DESCRIPTION OF PROPOSED CHANGE AND SAFETY AND ENVIRONMENTAL ANALYSIS PROPOSED CHANGE NO. 85 TO THE TECHNICAL SPECIFICATIONS PROVISIONAL OPERATING LICENSE DPR-13

This is a request to revise Technical Specification 6.0 of Appendix A, and Environmental Technical Specification 5.0 of Appendix B.

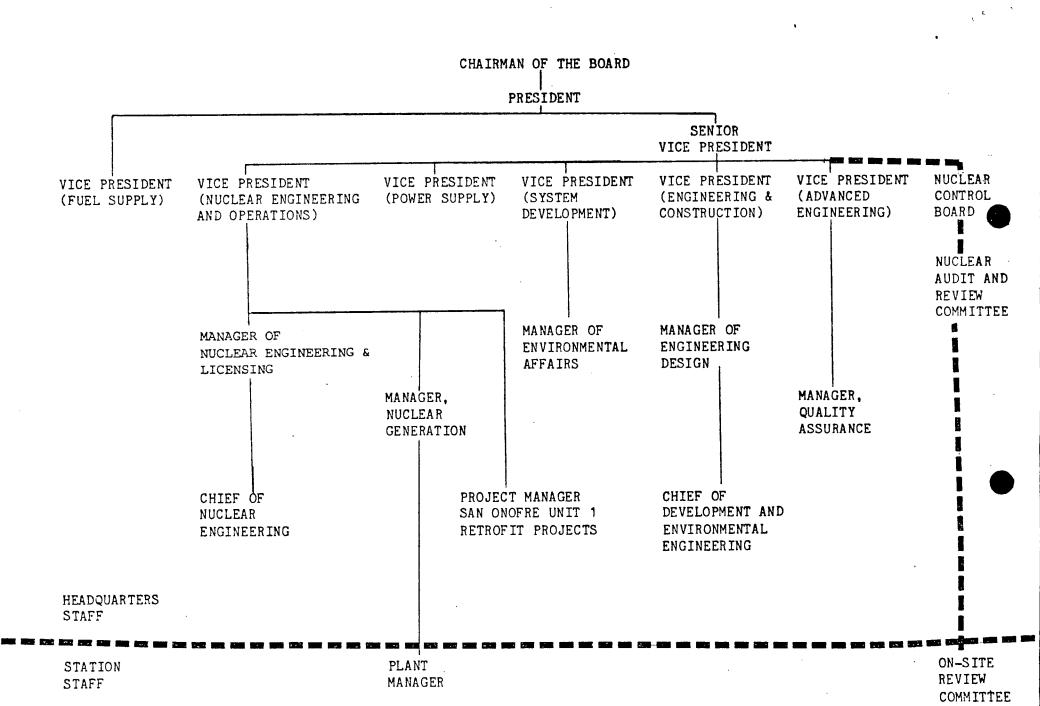
Revised Figures 6.2.1.1, Offsite Organization and 6.2.3.1, Fire Protection Staff and Line Organizations are attached.

Figure 6.2.3.1
FIRE PROTECTION STAFF AND LINE ORGANIZATIONS

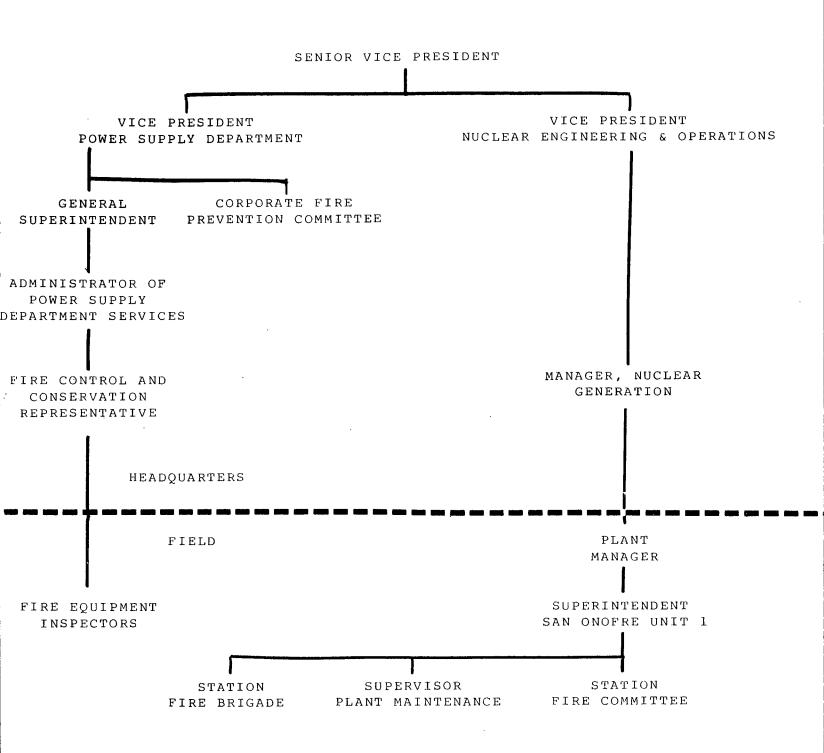
(4) 6.2.3 Fire Protection Organizations

The responsibility for the Fire Protection Program at the San Onofre Nuclear Generating Station Unit 1 is vested in the Senior Vice President. The implementation of this program is delegated to staff and line organizations within the Nuclear Engineering and Operations Department and the Power Supply Department as shown in Figure 6.2.3.1.
